# **AVISTA CORPORATION**

## **SPOKANE RIVER WATER TEMPERATURE AND DISCHARGE FLOW MONITORING PLAN**

**Spokane River Hydroelectric Project  
FERC Project No. 2545**

*May 11, 2010*

**FIGURE 1.** Map of the Upper Spokane River with Flow and Temperature Monitoring Stations

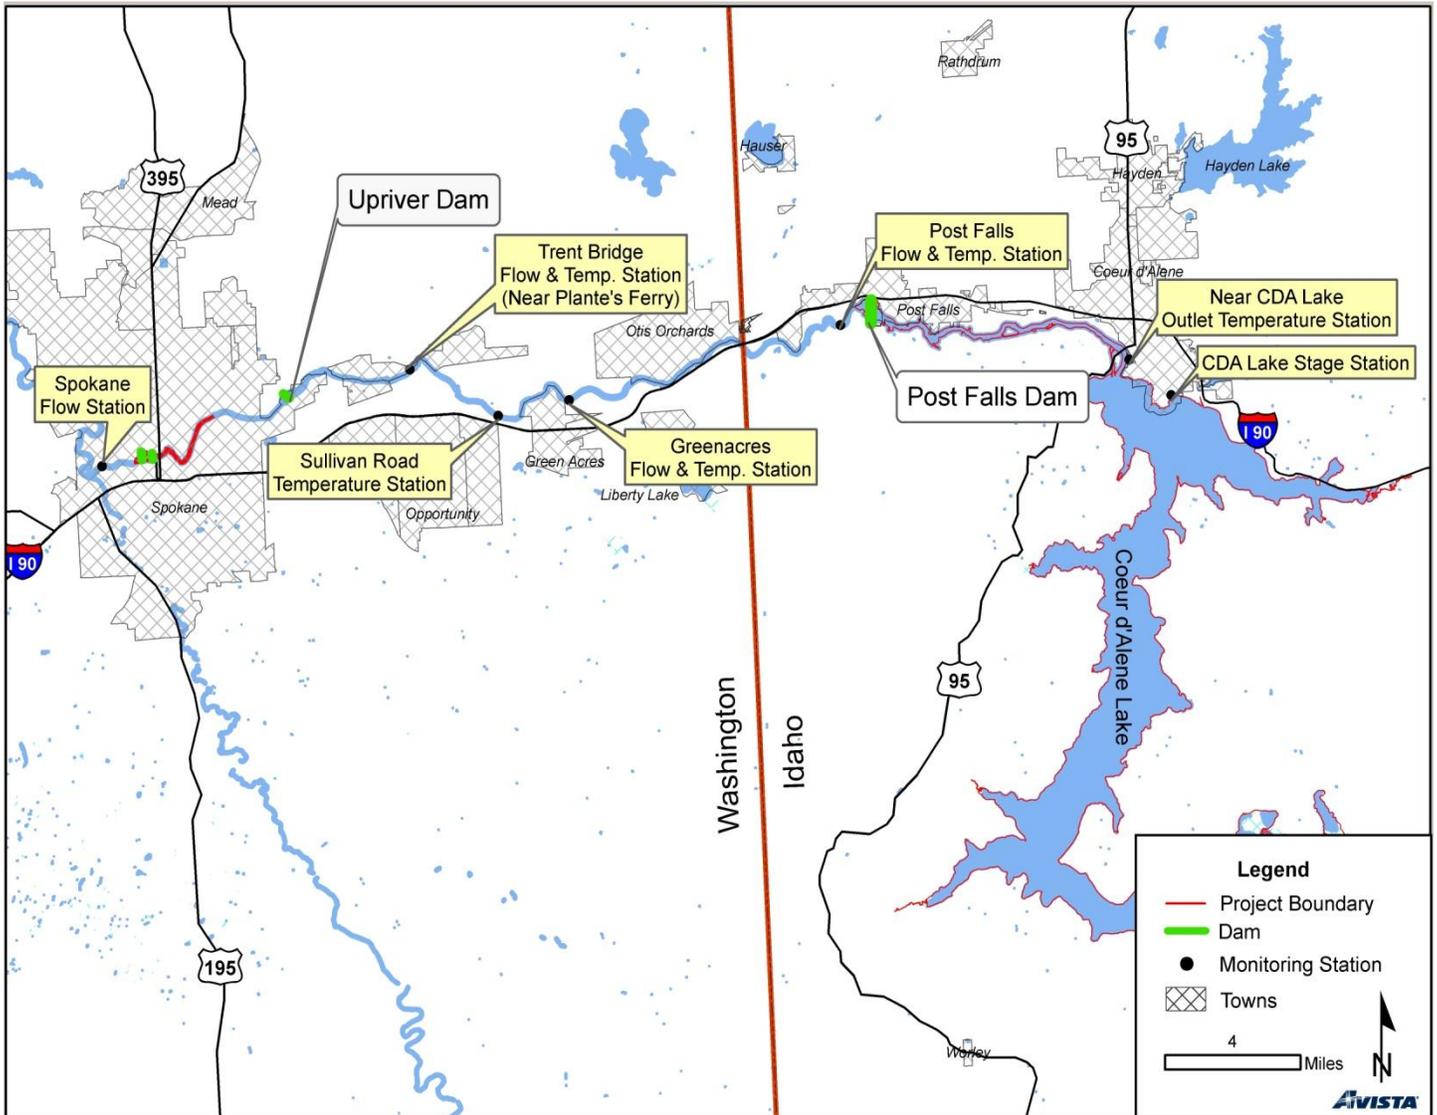
WDFW opposes the choice to monitor flow at a location 300 feet upstream of the Sullivan Road Bridge. This specific location is a transition point in the river where the aquifer input to the river begins which results in flow increases and declining water temperature. At any point above this location or below this location, the temperature and flow characteristics of the river can dramatically change. In a USGS report (Hsieh et al., 2007), seepage runs conducted in 2005 indicated the Spokane River loses water to the aquifer from Post Falls Dam to Flora Road, and that the river gains water downstream of Flora Road. Flora Road is located 1.3 miles upstream of Sullivan Road. Gregory and Covert (2005) measured stream-water temperatures to detect ground-water discharge to the river and found the river gains water below Sullivan Road causing river temperatures to rapidly decrease (see figure below from Gregory and Covert, 2005). Depending on the year and season, locations of ground-water inputs to the river and temperature influences vary at the Sullivan Road location (Hsieh et al., 2007).

Due to the variability of significant ground-water influence around Sullivan Road and because flow data is not going to be collected at this location, WDFW requests that the Sullivan Road monitoring location be omitted from the Monitoring Plan. The value of data from this monitoring location is not indicative of overall habitat characteristics in the Spokane River immediately above or below this location, and therefore this data should not be factored into decision making. We request that the Monitoring Plan focus on collecting flow *and* temperature data in the Spokane River at the other locations included in the Monitoring Plan. The locations near Post Falls Dam, Greenacres, Trent Bridge, and Spokane should provide data representative of river conditions generally found in those reaches. We request temperature data be collected at the Spokane monitoring location and believe the data collected here would be of value.

WDFW opposes the choice to monitor flow at a location 300 feet upstream of the Sullivan Road Bridge. WDFW requests that the Sullivan Road monitoring location be omitted from the Monitoring Plan.

*Flow will not be monitored at a location 300 feet upstream of the Sullivan Road Bridge. However, monitoring of water temperature at the Sullivan Road location will remain in the Plan. The Sullivan station is at the same location where water temperature data was previously collected and reported in Avista Environmental Affairs Memorandum, Spokane River Temperatures, August 24, 2004, and the Graphs of Instream Flow Scenario Results, Presentation and Handouts, Robert Anderson, Golder and Associates, August 2004. In order to “evaluate the data assumptions upon which the required discharge flows are based” it is critical that we collect data from the same location that our data and assumptions were originally gathered. This area of the Spokane River is the furthest upstream site where changes in flow are known to affect water temperatures and is necessary to understand the relationship between flow and temperature. WDFW concerns regarding groundwater inputs and temperature variability at the Sullivan Road location is addressed in the QAPP section 4.1.4 under representativeness.*
